#### POTENTIALLY UNQUALIFIED COMPONENT IN CERTAIN ALLEN BRADLEY TIMING RELAYS

"Report of potential 10 CFR Part 21, Allen Bradley Timing Relay Model 700RTC

**UPDATE** - Report of potential 10CFR Part 21, Allen Bradley Timing  
Relay Model 700RTC  
Report No: P21-04302015, Rev. 3

Part 21 Report No: P21-04302015, Rev. 3

Figure 2 - New design circuit board and CPLD that replaced the original component.

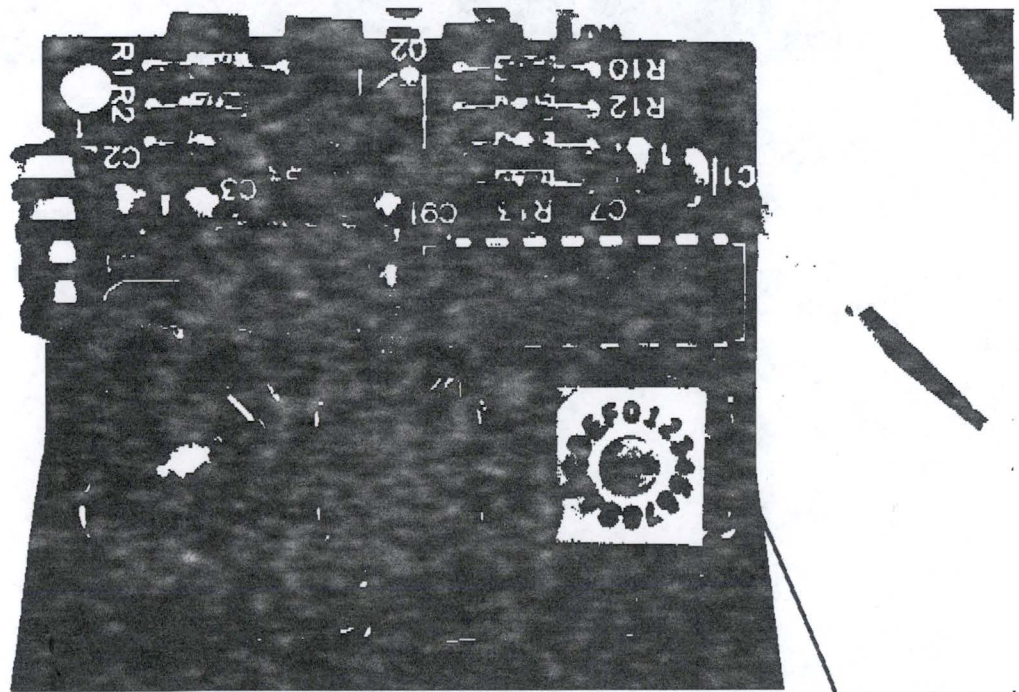
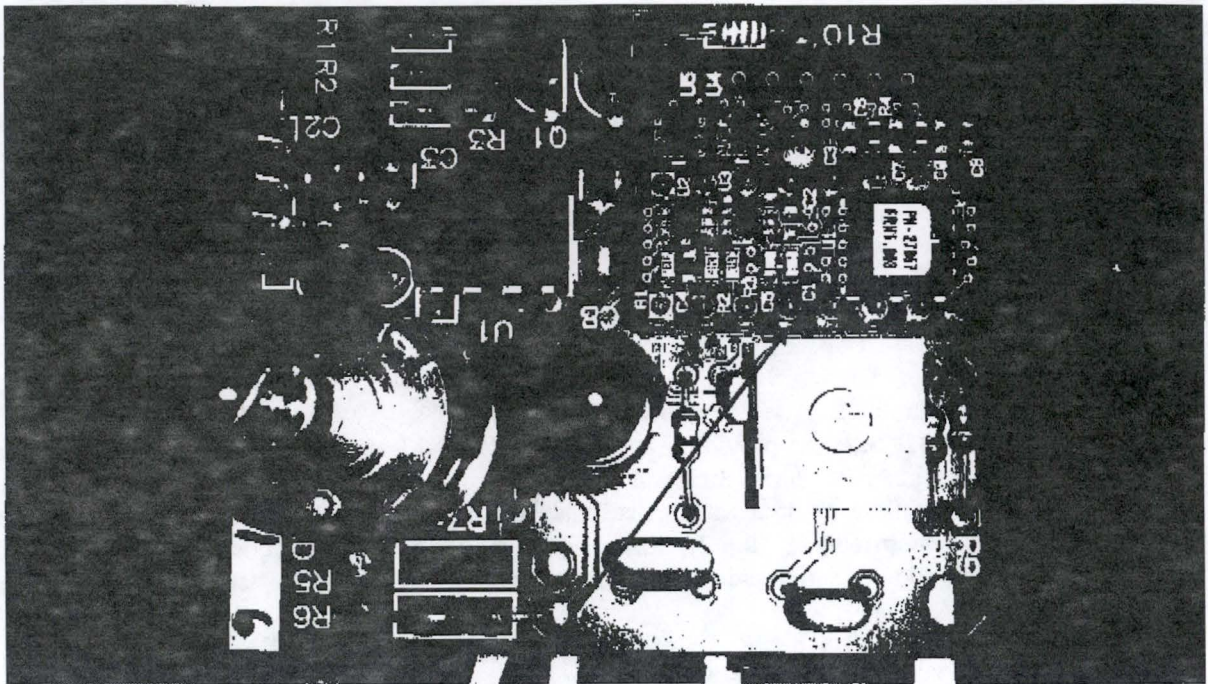
In October 2008, Allen Bradley made a design change without changing the part number of the commercial relay or providing any documented evidence of a design change. The manufacturer specification data sheets maintain the classification that the relays are "solid state", which would imply that there are no digital devices installed in the relay. However, after inspection of the internals of the timing relay (Figure 2), it has been identified that the unit does contain a CPLD which meets the definition of a digital device under the guidance of NEI 01-01. See Figures 1 and 2 below:

The results were satisfactory with exception of the following condition: During Conducted Susceptibility CS114 onto the power lines, with the timing circuit in operation, the instantaneous contacts exhibited chatter in the range of 2.6 MHz to 20.3 MHz. The unit requires a ferrite to be installed onto the input power lines of the relay with 3 turns through the ferrite core. In this modified configuration, the relay was not susceptible to Conducted Susceptibility and successfully passed the required test per CS114.

The relays are dedicated for generic application usage in timing applications. The specific plant application(s) is unknown by NLI. The EMC qualification of the relay is dependent on the installed configuration and location in the plant. The plant should evaluate whether the installed relays are subjected to the specific EMI/RFI condition Conducted Susceptibility CS114 between the frequencies of 2.6 MHz to 20.3 MHz identified above.
